MFN 08-849

**Subject: Response to Portion of NRC Request for Additional Information
Letter No. 229 - Related To Design Control Document (DCD)
Revision 5 – RAI Number 4.2-29**

**Response to Portion of NRC Request for
Additional Information Letter No. 229
Related to ESBWR Design Certification Application
RAI Number 4.2-29**

NRC RAI 4.2-29

Figure 4.1-1. ~~Core Configuration with Location of Instrumentation~~ Fuel Bundle, Neutron Sources, Neutron Detectors and Control Rod Arrangement

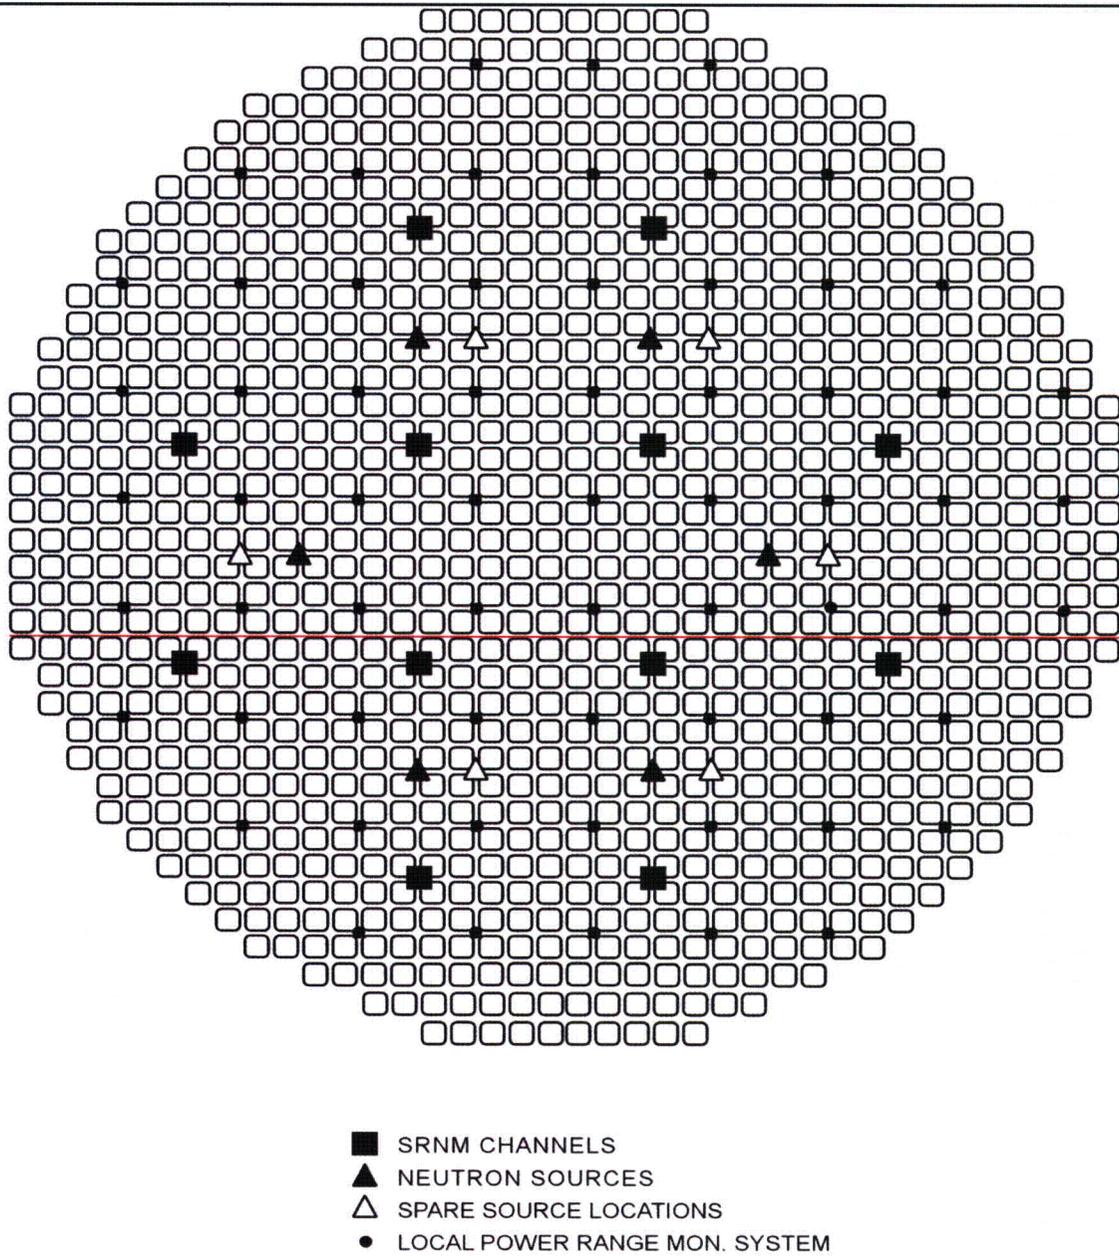
The principle fuel design requirements added to ESBWR DCD Revision 5, Tier 2, Section 4B.1 (formerly Tier 1 design requirements) should be designated Tier 2. Similarly, Figure 4.1-1 should be designated Tier 2*.*

DCD Tier 2, Figure 4.1-1 will not be designated Tier 2*, because Tier 1 Figure 2.1.1-2 includes the essential core design elements. DCD Tier 2, Figure 4.1-1 will be updated for consistency throughout the DCD.

DCD Tier 2, Section 4B.1 and Figure 4.1-1 will be revised as shown in the Enclosure 2 markups.
